Thursday, October 22, 2026 7:00 PM
Educational Services Center (ESC), 401 E. Hancock Street, Lansdale, PA 19446

RE: North Penn High School BP-2
Change Order Request #23 ASI 01 – Additional Shaft wall

PROJECT: *(name and address)* North Penn High School Renovations Bid Package 2	**CONTRACT INFORMATION:** Contract For: Mechanical Construction Date: 08-14-2026	**ASI INFORMATION:** ASI Number: 01 Date: 01-20-2026
OWNER: *(name and address)* North Penn School District 401 E. Hancock Street Landsdale, PA 19446	**ARCHITECT:** *(name and address)* Hord Coplan Macht, Inc. d/b/a SCHRADERGROUP Studio 555 E. North Lane, Suite 5100 Conshohocken , PA 19428	**CONTRACTOR:** *(name and address)* JBM Mechanical, Inc 3273 Gun Club Road Nazareth, PA 18064

BP2-A708 SCALE: 1 1/2" = 1'-0"

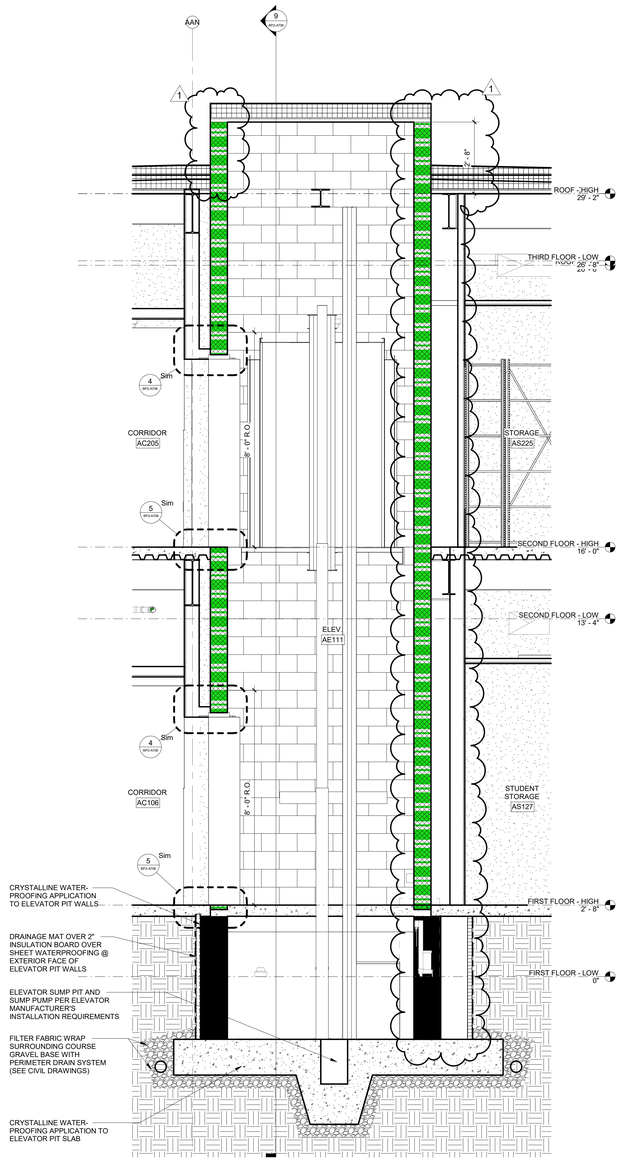
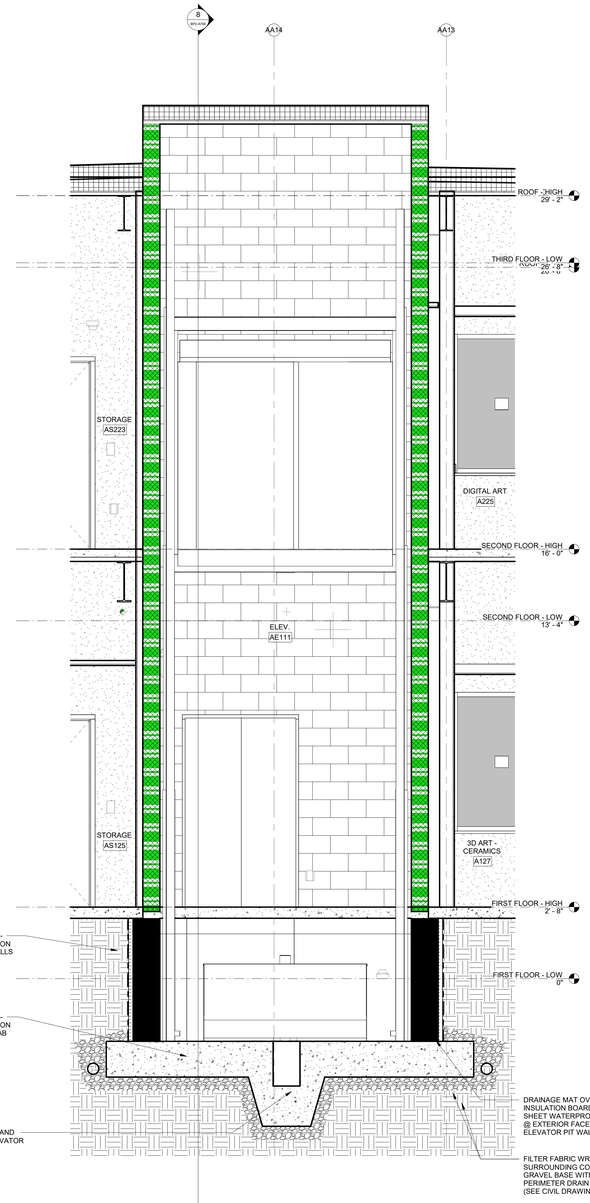
Please see below the costs associated with the changes listed in ASI 01, issued 01-26-2026. This proposal includes providing and installing an added Layer of 1" Shaft Liner to Elevator Doors per Details 4 and 6/BP2-A708.

- **Added Layer of 1" Shaft Liner to Elevator Doors per Details 4 and 6/BP2-A708 of ASI-001.**

Revisions to Structrual Set:
- Modifications to structural steel framing adjacent to elevator shaft shall be made per revised sheet BP2-A708 and reflected on Revise & Resubmit For Record submittals.

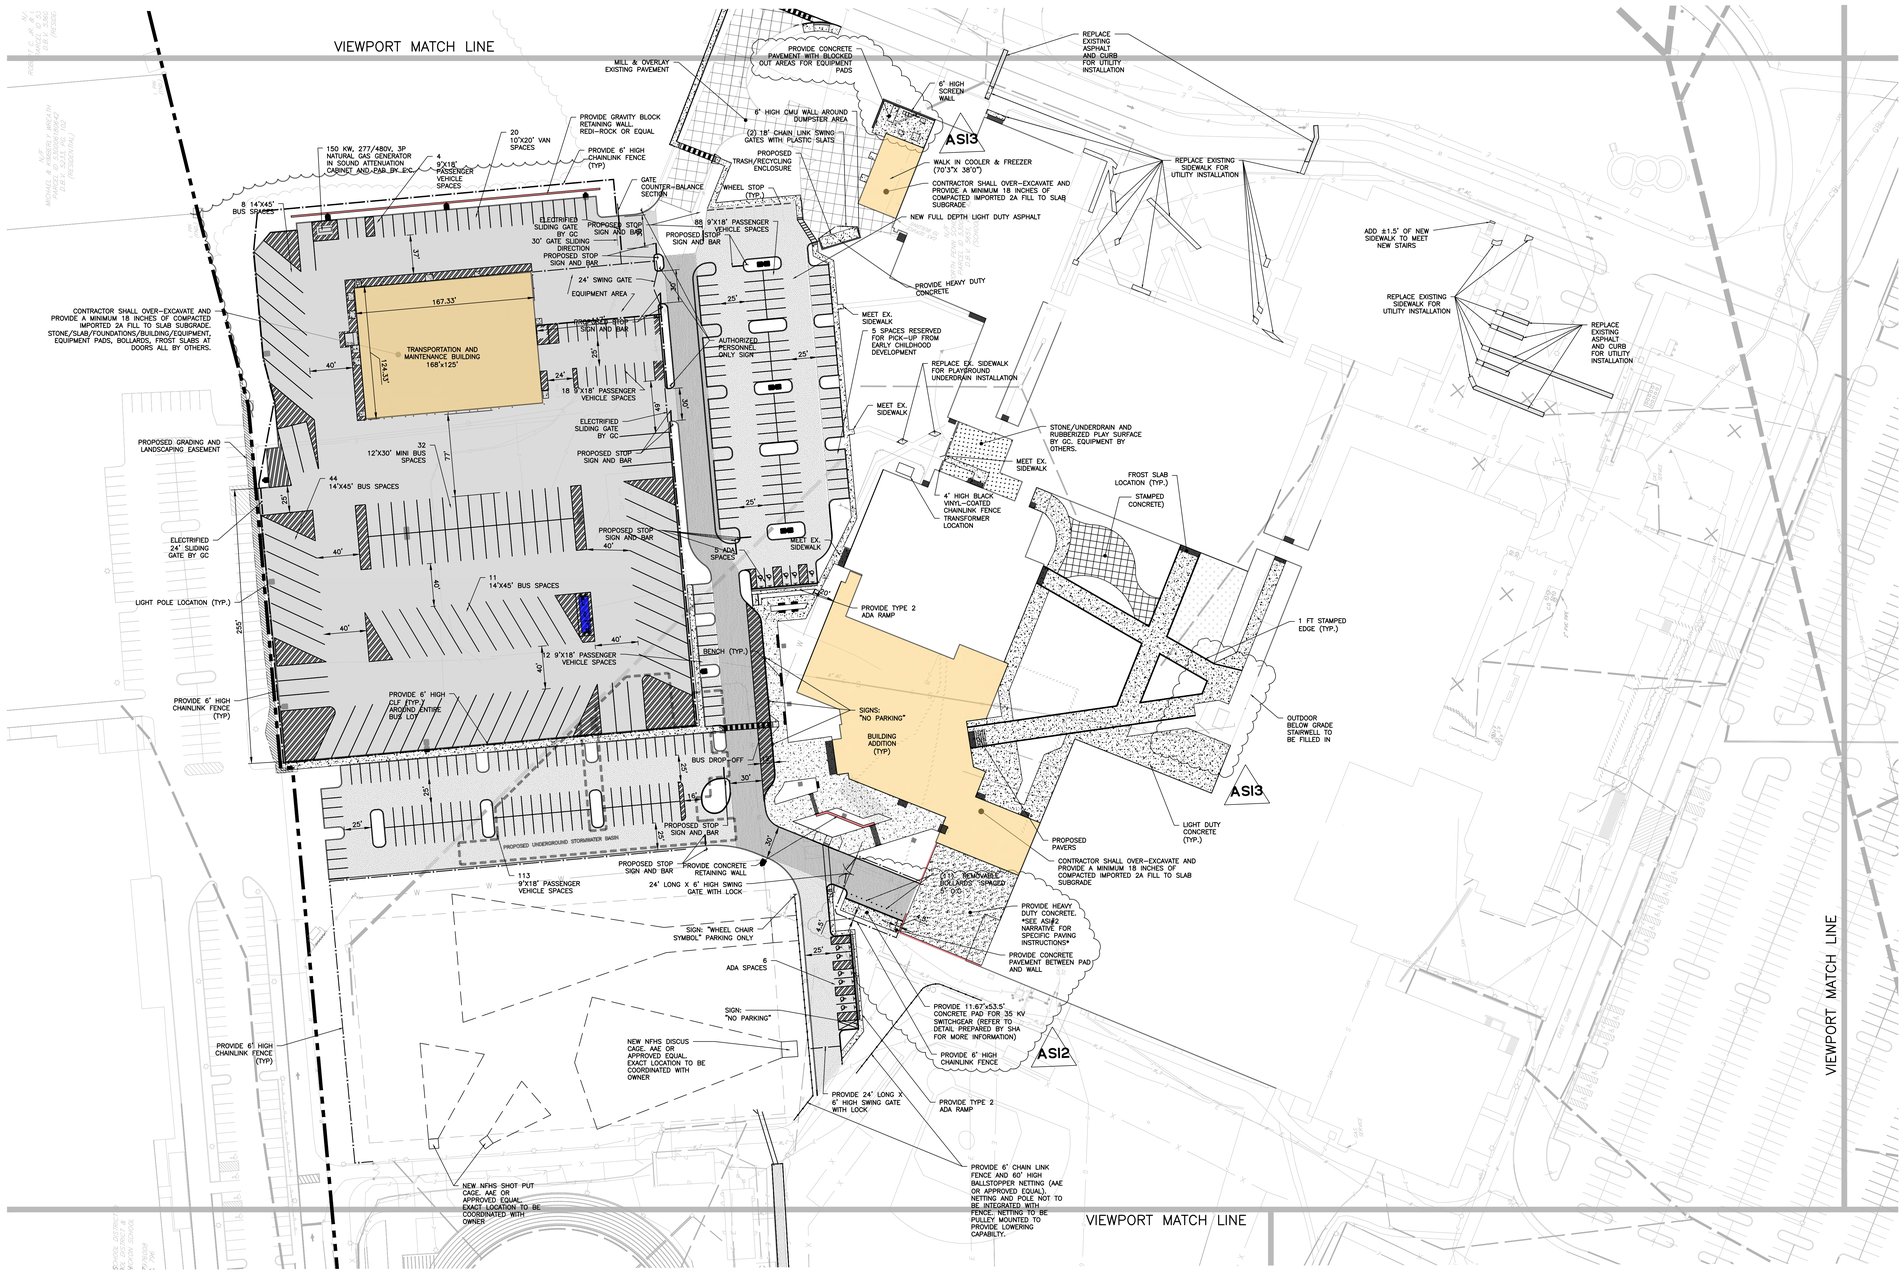
- **To raise the existing inlet in Area B Equipment Yard to allow proper drainage**

4. Utility Plan A (BP2-C022) has been modified to make plan revisions including but not limited to:
   - **To show the added structure B62B connection to the roofdrains leading to B62.**
     *** Please note that while this drawing shows the revised ductbank routing to Sumneytown Pike from ASI#2, revised E&S drawings BP2-C027 and BP2-C028 will first be submitted to the conversation district for review and approval of this as a field change. The review process is expected to parallel WEC's duct bank test pit digs. Work on the electrical duct bank should not commence until both the routing is considered viable with minimal rock removal expected and approval is received from the conservation district.**

Drawing Number:
BP2- C039

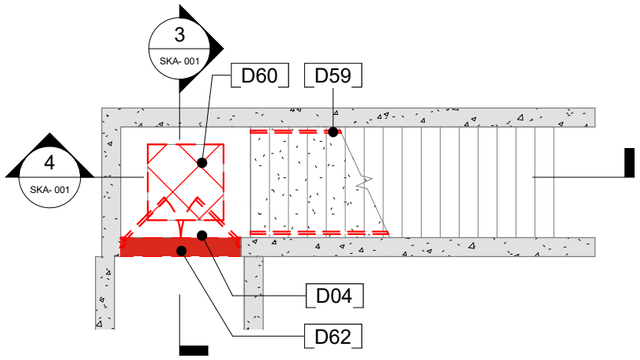
5. Courtyard Detailed Plan (BP2-C039) has been modified to make plan revisions including but not limited to:
   - **To revise proposed courtyard hardscape footprint and retain existing generator.**
   - **To revise extents of concrete path near the Southwest entrance(s) to the interior courtyard.**

Drawing Title:
EXTERIOR STAIR DEMOLITION

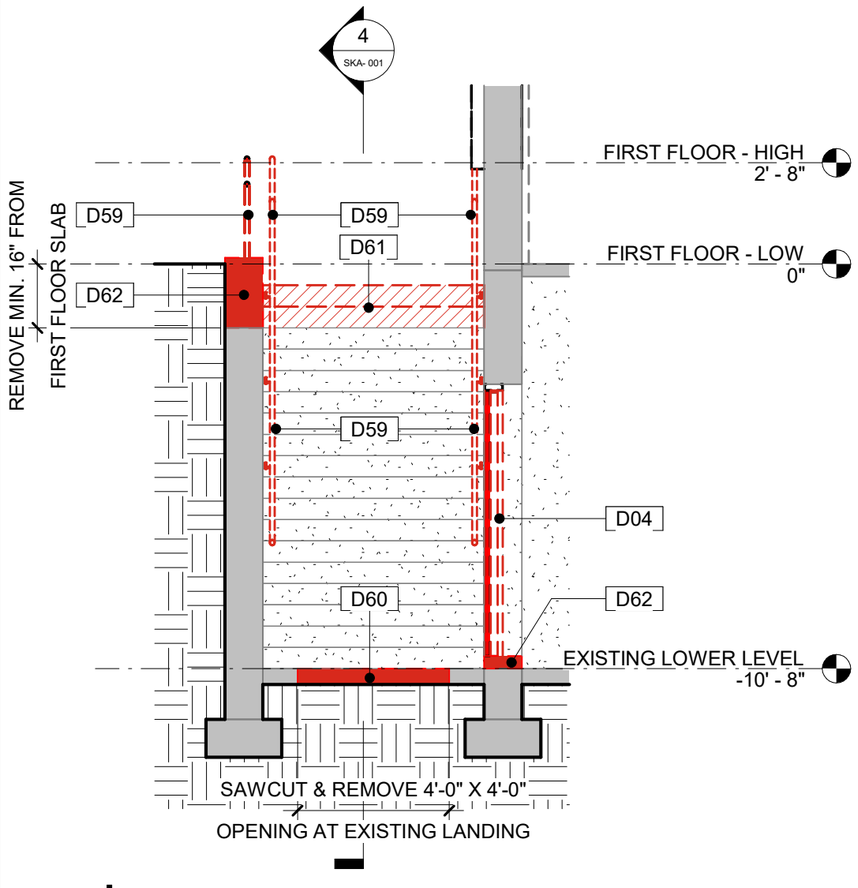
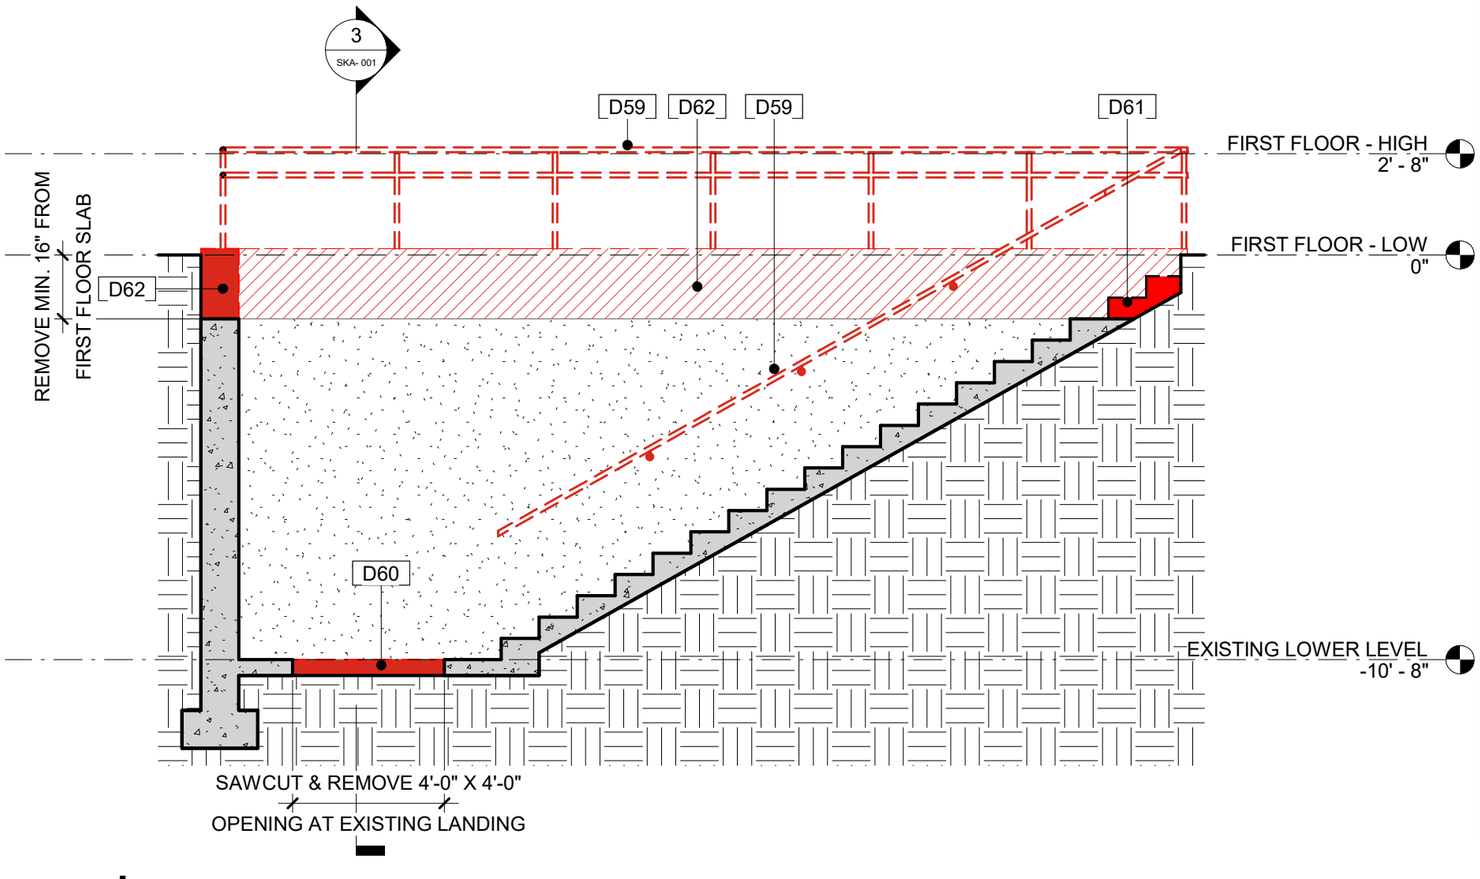
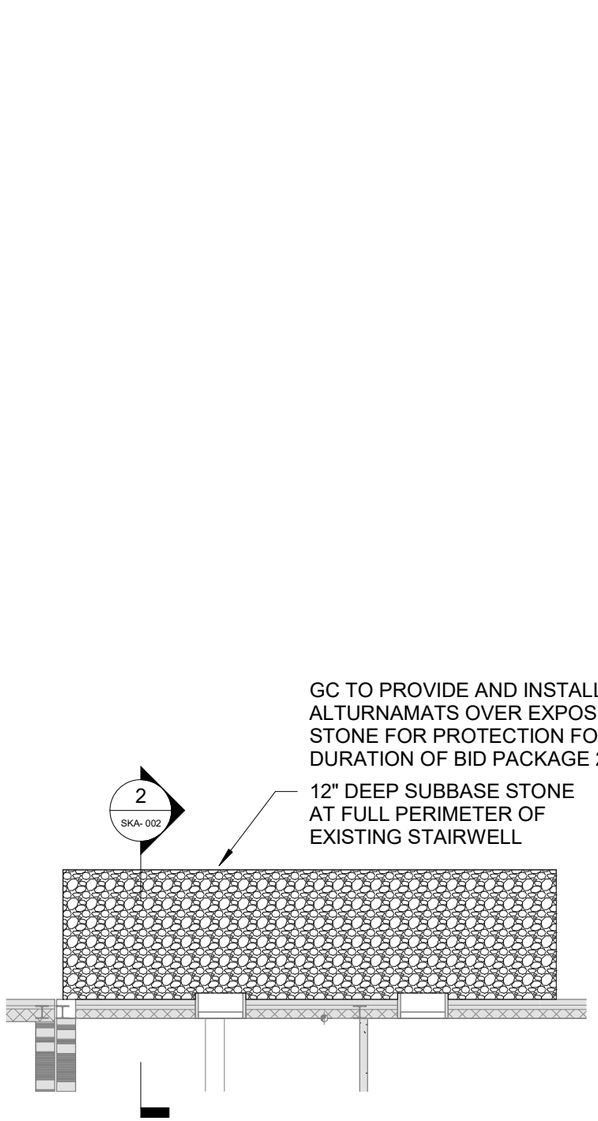
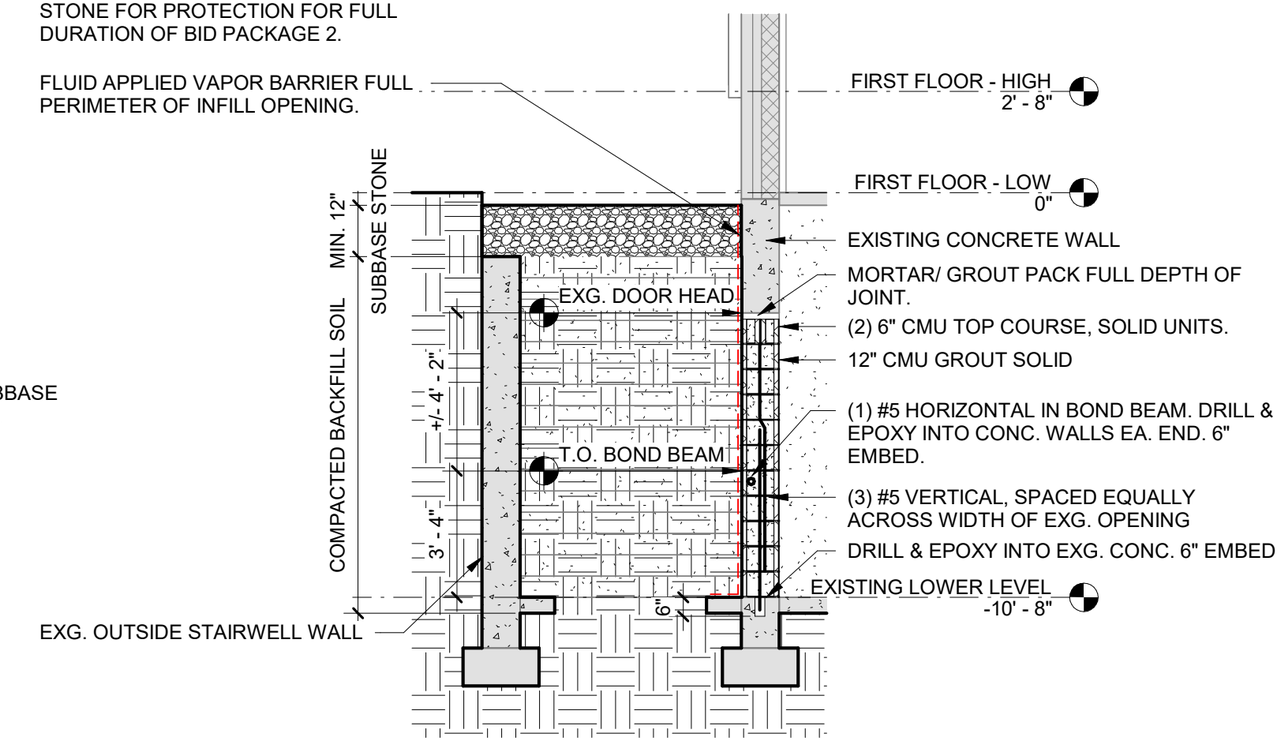
3.03 Sketch BP2-SKA-001; ADD sketch BP2-SKA-001 dated 03/16/2026.
3.04 Sketch BP2-SKA-002; ADD sketch BP2-SKA-002 dated 03/15/2026.

BP2-CSKE-10 SCALE: 1/8" = 1'-0"

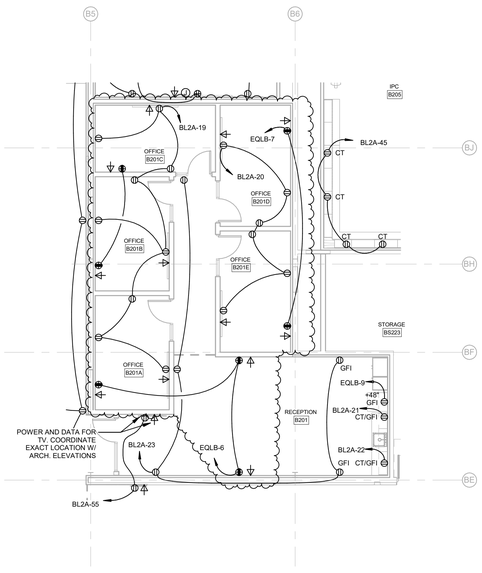
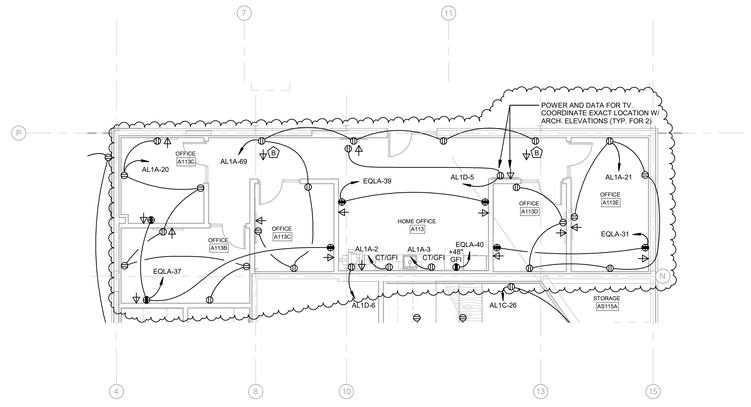
- PCO #12: Revised size of 5KV pad to increase coverage - $8,773.00
- PCO #13: ASI #14 Office Power revisions - $2,123.15
- PCO #15: Demolition of floor boxes not shown on contract documents, per RFI #EC-0038 - $7,232.38

14.03 Sketch BP2-CSKE-10; **ADD** sketch BP2-CSKE-10 dated 06/18/2026.

BP2-A708 SCALE: 1 1/2" = 1'-0"

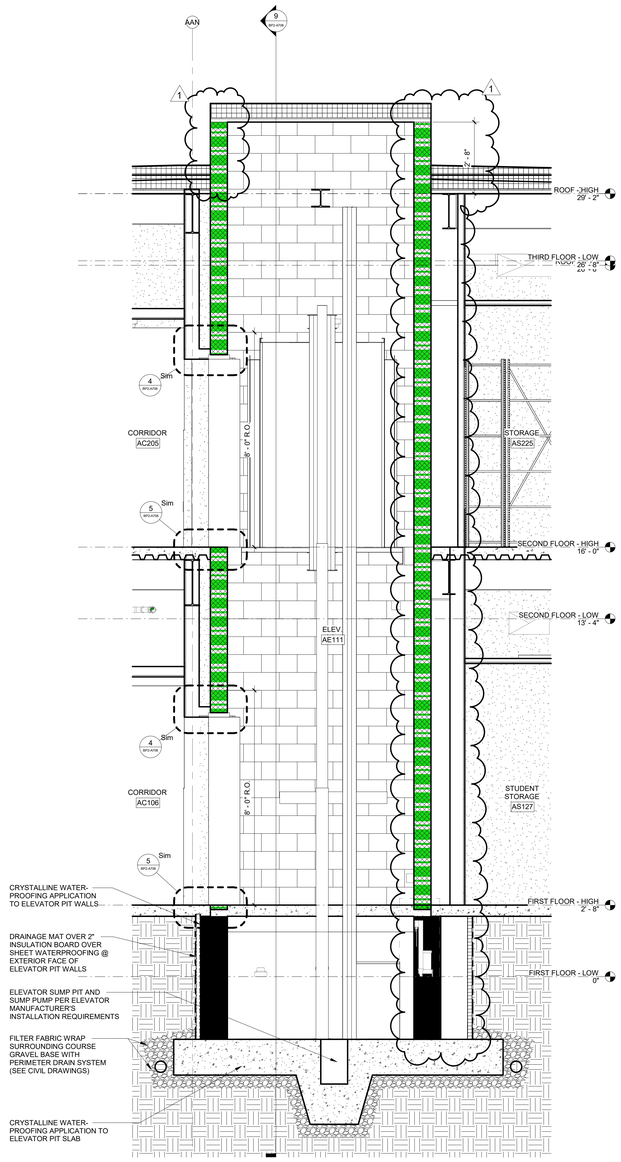
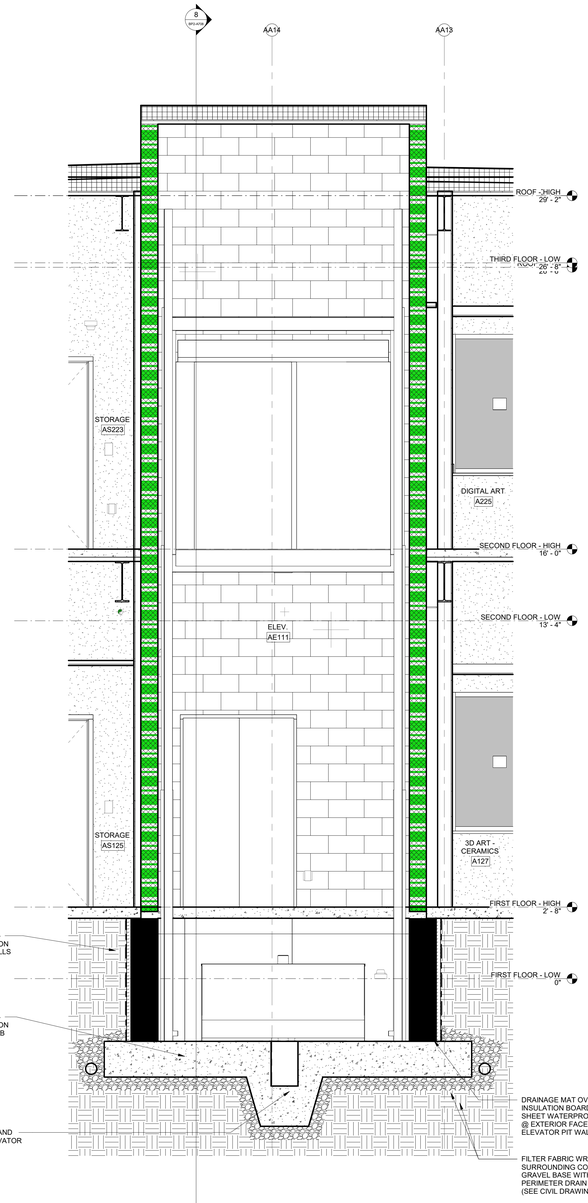
Please see below the costs associated with the changes listed in ASI 01, issued 01-26-2026. This proposal includes providing and installing an added Layer of 1" Shaft Liner to Elevator Doors per Details 4 and 6/BP2-A708.

- **Added Layer of 1" Shaft Liner to Elevator Doors per Details 4 and 6/BP2-A708 of ASI-001.**

Revisions to Structrual Set:
- Modifications to structural steel framing adjacent to elevator shaft shall be made per revised sheet BP2-A708 and reflected on Revise & Resubmit For Record submittals.
